**BROOKHAVEN NATIONAL LABORATORY
UPTON, SUFFOLK COUNTY, NEW YORK
EPA FACILITY ID: NY7890008975
JULY 6, 2011**

PUBLIC HEALTH ASSESSMENT

BROOKHAVEN NATIONAL LABORATORY

A public health assessment (PHA) for the Department of Energy's (DOE) Brookhaven National Laboratory was released for public comment and independent peer review on September 30, 2005. Due to a lack of funding by DOE in fiscal year 2006, we were unable to respond to the comments we received. PHA Appendix H contains a copy of the stakeholder letter sent in December 2005.

Figure 3. Ten-year tritium releases from HFBR: 1994 to 2003

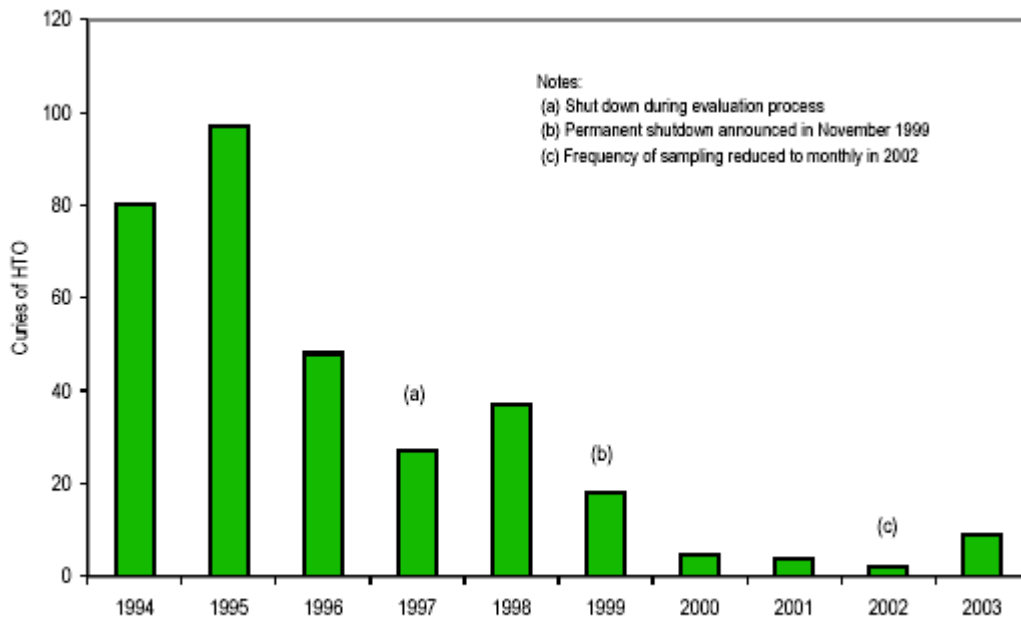
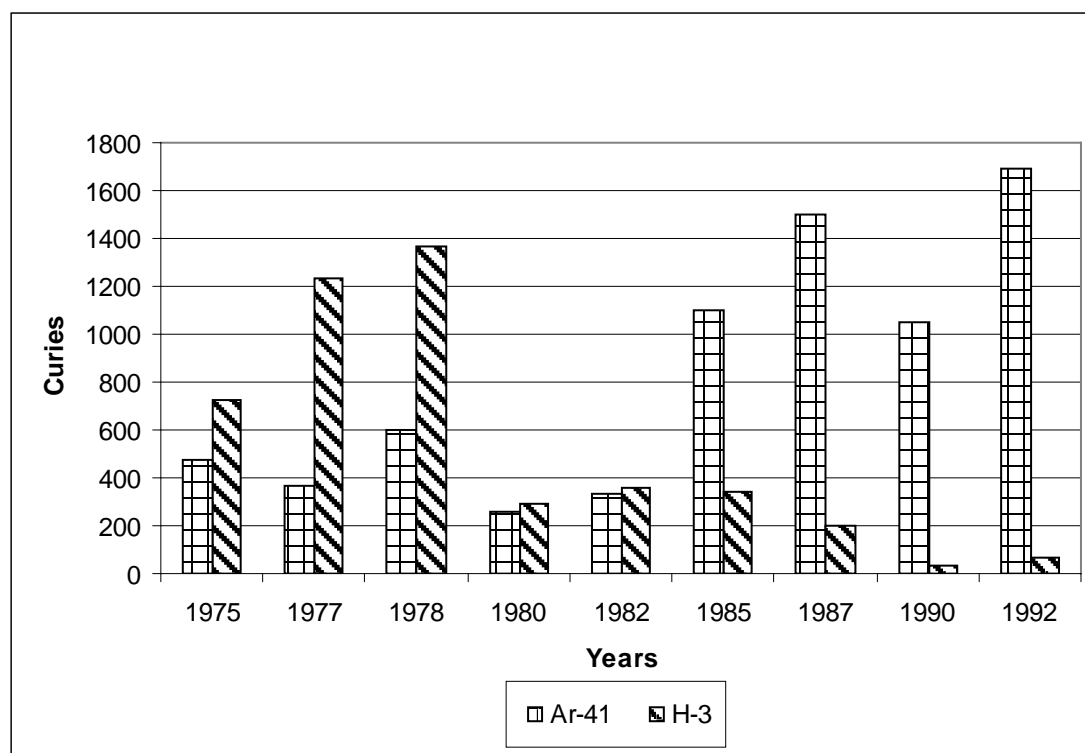
<p>figure 3) when it has not been in operation?</p>	<p>November 1999. While this increase may seem unusual, readers should note that the magnitude of the increase is extremely small in comparison to past tritium emissions when this and other reactors were operational. For instance, as comparison of Figures 2 and 3 shows, the longer-term trend of tritium emissions from the HFBR quite clearly demonstrates (as one would expect) that air emissions in every year since shutdown were considerably lower than air emissions during years of active operations. Moreover, as comparison of Figures 1 and 3 shows, the historical emissions of tritium from the Van De Graaff Accelerator (VDGG) operations far outweigh the recent increase in tritium emissions observed in 2002.</p> <p>Nonetheless, to be responsive to this comment, ATSDR has added text to the section in question offering some explanations for why the tritium emissions recently increased (e.g., due to evaporative losses during groundwater remediation activities), and ATSDR has revised the titles of Figures 1, 2, and 3 to emphasize the different time frames that the individual figures cover.</p>

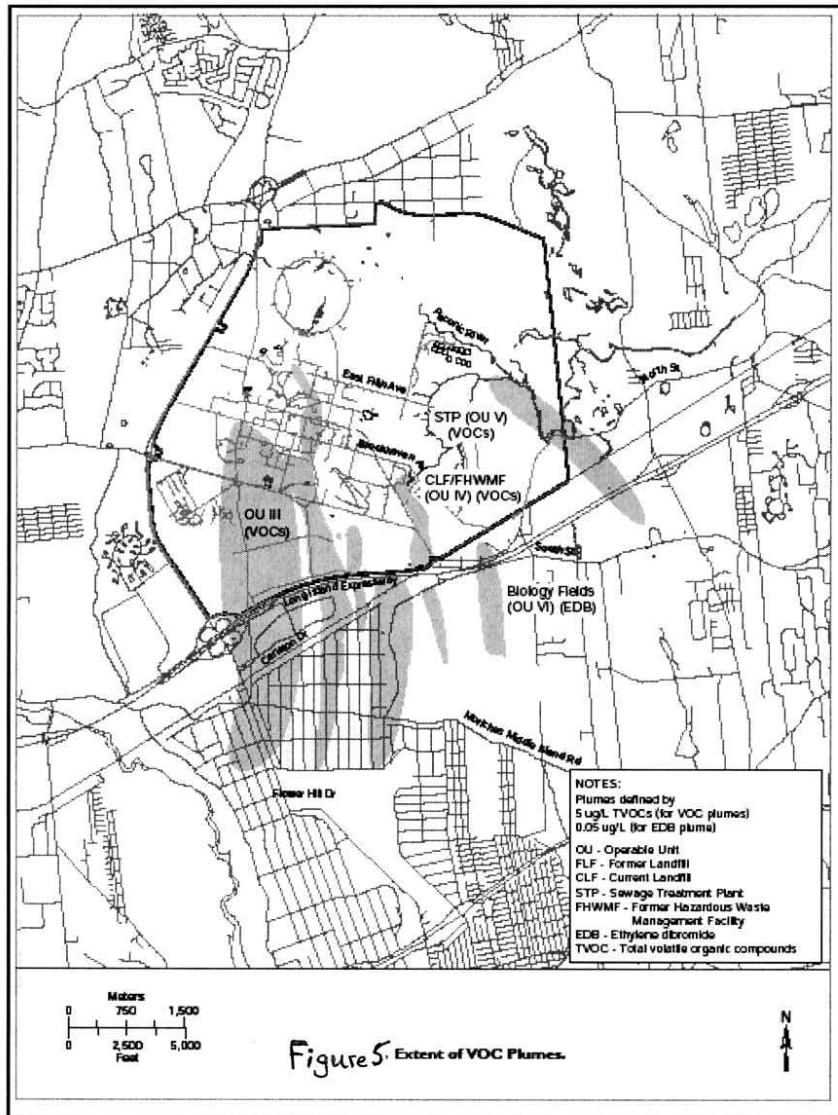
37	<p>Page 23 – The figure referred to in the last paragraph should be Figure 5 in Appendix B, which should be modified to include labels with the plume numbers.</p>	<p>ATSDR has revised the text in question to clarify that Figure 5 appears in Appendix B of the PHA and has replaced the version of Figure 5 that appeared in the Public Comment Release PHA with a new figure taken from BNL’s 2005 Site Environmental Report. This new figure has text labels for the plumes that are consistent with the names of the plumes listed in Table 2 of the PHA.</p>
38	<p>Figure 5 (page B-6) and Figure 5a (page B-7): The public water hookup area is not correct on these figures. A correct figure can be generated for ATSDR.</p>	<p>None of the text in the Public Comment Release PHA previously referred to Figure 5a, thus ATSDR decided to delete the figure from the document. As the response to the previous comment notes, ATSDR has replaced the version of Figure 5 that previously appeared in the Public Comment Release PHA with an updated image. These revisions have helped ensure that the PHA shows the most up-to-date information on the extent of groundwater plumes, which ATSDR believes is more relevant to the PHA discussion than showing the hookup areas (given that nearly every resident eligible for the hookup has received one).</p>

40	Page B-6 – Figure 5 still indicates “Proposed Hookup Area IV;” the word “proposed” should be eliminated.	ATSDR has replaced the figure in question (see response to Comment #37) with a more current figure. Thus, the editorial suggestion in this comment no longer applies.
41	Page B-7 – Figure 5a needs to include Hookup Areas III & IV.	As the response to Comment #38 indicates, ATSDR has deleted the figure in question.
42	Page 7 – Summary/Air Pathway: The report refers to a “lifetime dose recommendation” for potential radiation exposures estimated by ATSDR. This wording needs to be changed to reflect that it is a recommended dose limit, as opposed to recommended dose.	<p>The comment correctly notes that the terminology used on page 7 in the Public Comment Release PHA was incorrect. However, ATSDR does not have a recommended lifetime dose limit, as the comment suggests. Rather, ATSDR typically compares estimated <i>annual</i> radiation doses to a minimal risk level (MRL) of 100 mrem/year and <i>lifetime</i> doses to ATSDR’s radiogenic cancer comparison value of 5,000 mrem over 70 years. ATSDR uses these comparison values to determine whether radiation exposures require further investigation. Estimated doses that are below ATSDR’s comparison values would not be expected to result in adverse health effects, and therefore would be considered safe. ATSDR’s comparison values are discussed in detail in the responses to comments #47 and #49</p> <p>Note that 100 mrem/year is not only ATSDR’s minimal risk level, but this value is also the annual dose limit recommended for the public by the International Commission on Radiological Protection (ICRP), the National Council on Radiation Protection and Measurements (NCRP), and the US Nuclear Regulatory Commission (NRC).</p> <p>To respond to this comment, ATSDR carefully reviewed the PHA and replaced all language regarding the lifetime dose recommendation with text reflecting</p>
